RE: Dam and Spillway Condition Assessment
Final Report

DAM & SPILLWAY ASSESSMENT REPORT

DAM: Frog Pond Lake Dam

Capco Engineering, Inc. Response to Comments From WCID Board in Letter Dated March 20, 2020

Photograph No. 4 – Standing on the left portion of the dam looking South East.

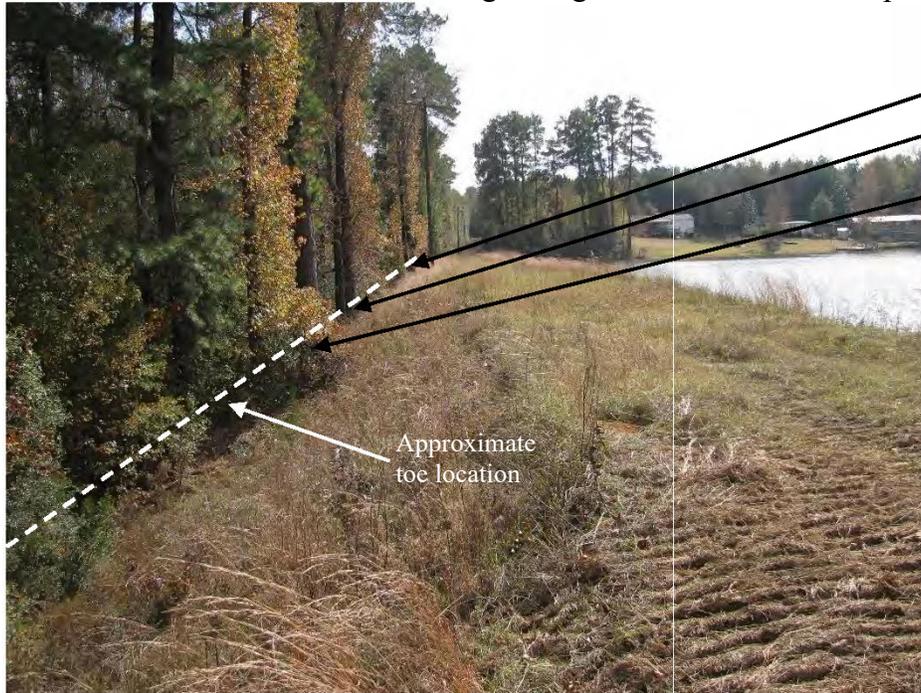
- The 15-ft wide crest of the dam had a well-maintained vegetated cover on most of the length with a few deficiencies observed (Photos 1, 3, 4, 6, 7, 25 & 32).
- The crest was found to be in good condition.
- Effort was being made on the left end to establish a vegetative cover with the aid of an erosion control blanket (Photos 1, 3, 4, 6 & 7).

- The downstream slope generally had a 2H:1V slope with some areas slightly steeper that had an undulated appearance. The slope had a well-maintained vegetated cover with a few large trees; however, the toe was significantly overgrown with large trees and brush (Photos 2, 4, 5, 13, 27 & 35).
- A few bare areas and surface erosion were observed along the slope (Photos 21, 24 & 25).
- Holes caused by two large fallen trees were observed (Photos 21, 22, 23 & 26). These holes must be filled soon.
- Varmint holes (Photos 14, 16).
- An embankment slope sag caused by growing tree (Photo 27).
- Seepage at the tree holes (Photo 21, 24).

Trees growing on the downstream slope

| PRIORITY | DESCRIPTION | OPC |
|----------|--|---------------------------|
| 2 | Clear along entire downstream slope and toe. Remove all trees 4" diameter and smaller. Clear of all debris and brush so a good visual inspection can be made of the downstream slope and toe. Fill all voids with well compacted select fill. | \$10,000 (Ref Q#1 & 5) |
